ACCELERATED DISTRIBUTION DEMONSTRATION SYSTEM

SUBJECT: Forwards mods to Responses 3,9,11 & 12,per 880615 telcon.SER
 requested for installation of equipment during 1989 outage.

Subject: Clarification of April 29, 1988 AMSAC Submittal
R.E. Ginna Nuclear Power Plant
Docket No. 50-244

MODIFICATIONS TO RG&E RESPONSES OF APRIL 29, 1988 ON AMSAC

TEST ELEMENTARY FOR AMSAC ISOLATION DEVICE

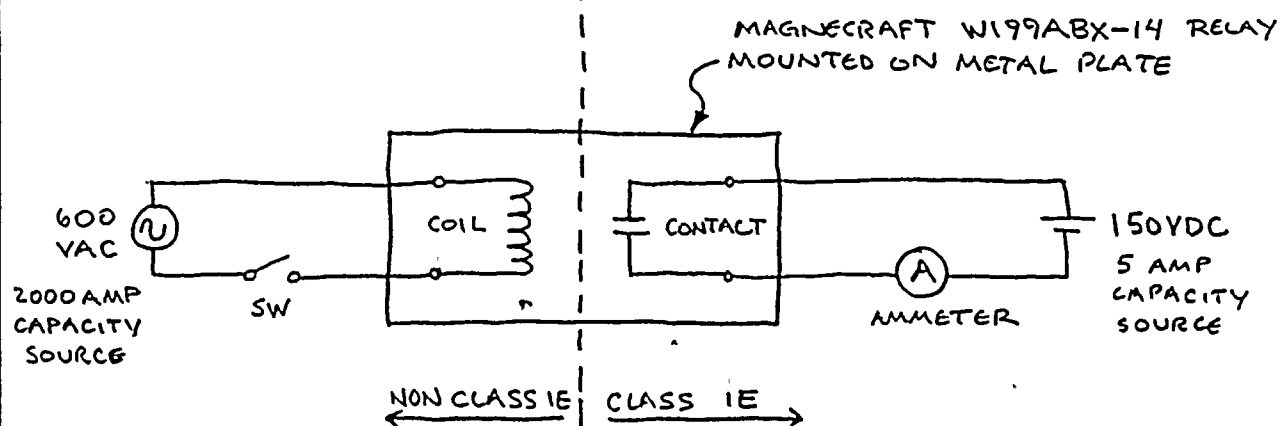
- a. For the type of device used to accomplish electrical isolation, describe the specific testing performed to demonstrate that the device is acceptable for its application(s). This description should include elementary diagrams when necessary to indicate the test configuration and how the maximum credible faults were applied to the devices.

- b. Data to verify that the maximum credible faults applied during the test were the maximum voltage/current to which the device could be exposed, and define how the maximum voltage/current was determined.

- c. Data to verify that the maximum credible fault was applied to the output of the device in the transverse mode (between signal and return) and other faults were considered (i.e., open and short circuits).

- d. Define the pass/fail acceptance criteria for each type of device.

- g. Provide information to verify that the Class 1E isolator is powered from a Class 1E source.

Refer to Attachment I for the AMSAC output relay test elementary and test procedure.

The AMSAC output relays will be located in the AMSAC instrument cabinet. The maximum available voltage and current in the AMSAC cabinet is a 120VAC/15 amp power feed to the cabinet. The test voltage documented in the qualification report was 600 volts. The power supply was capable of delivering 2000 amps at this voltage. These values clearly envelope this maximum credible fault.

Attachment I illustrates that the test fault was applied to the coil (non-Class 1E) side of the relay and the response measured at the contact output (Class 1E) side of the relay, satisfying the intent of this requirement. This type of destructive test also effectively demonstrates the response of the device to open and short circuits at the input terminals.

As indicated in Attachment I, the test acceptance criteria is zero current flow at the relay contact output terminals.

As illustrated in Attachment I, the coil side of the AMSAC output relay is connected to the non-Class 1E 120VAC AMSAC power source, and the contact output side is connected to the Class 1E 125VDC Auxiliary Feedwater Pump and Turbine Trip logic. No additional power sources are required for the operation of this electromechanical relay.

1. CLOSE SW. UNTIL COIL STABILIZES OR FAILS
2. OPEN SWITCH AND DISCONNECT 600VAC SOURCE
3. NEXT, RE-CONNECT 600VAC SOURCE: ONE LEAD ON METAL MOUNTING PLATE, OTHER LEAD FIRST TO ONE COIL TERMINAL, THEN TO OTHER COIL TERMINAL
4. OBSERVE CURRENT INDICATED ON AMMETER

ZERO CURRENT FLOW INDICATED ON AMMETER IN EACH CASE
